## Comments to WP.29-152-11

### On proportional speed fan

## Reasons on the technical inadequacy of WP.29-152-11

**Figure 1**

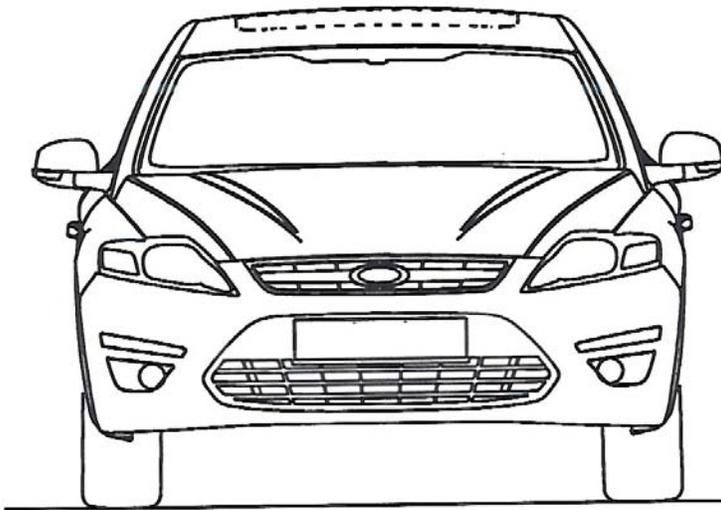
The following diagrams are examples of engine installations with intercoolers located substantially to the left of the vehicle centreline. Illustrations of associated frontal grill designs are also provided. These designs are typical of vehicles already on the market

Illustration of typical vehicle frontage – this gives no indication of location of emissions critical components (heat exchangers) which provide EGR cooling, charge air cooling etc and neither can anything be inferred about location of ducting behind the grills which would appropriately direct the air.

As these specific cooling requirements may not be obvious to third parties (i.e. other than the vehicle manufacturer), it is essential to retain the wording “at the request of the manufacturer”.

**Fig 2: Illustration of position of intercooler with advanced ducting to improve airflow**

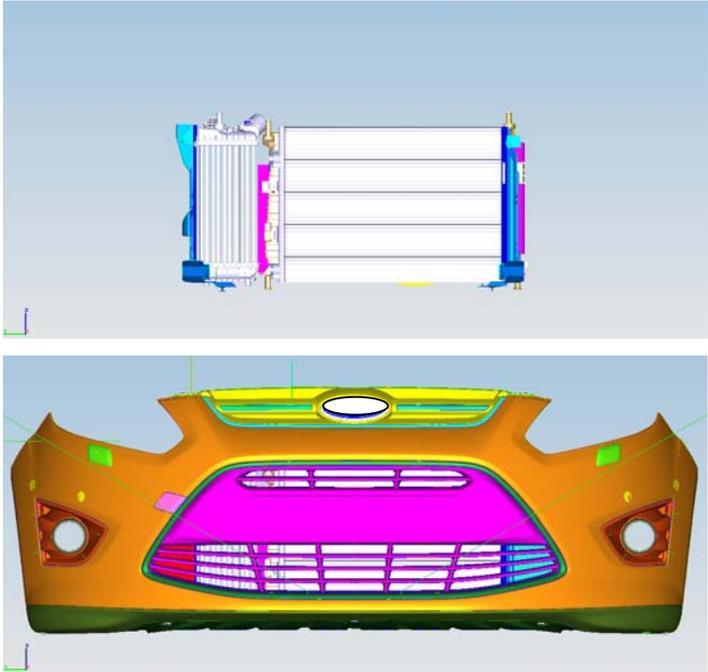
In the real world wind blows across the whole frontal area of the vehicle and it is vital that the air flow is able to be correctly directed to the vehicle intercoolers. Engineering constraints in engine bay packaging mean that intercoolers etc are often located away from the vehicle centre line. More sophisticated air ducting including the frontal grill are often used to correctly flow the air to the coolers (EGR coolers, intercoolers / charge air coolers etc). The air flow needs to be real world representative to the thermal management systems.
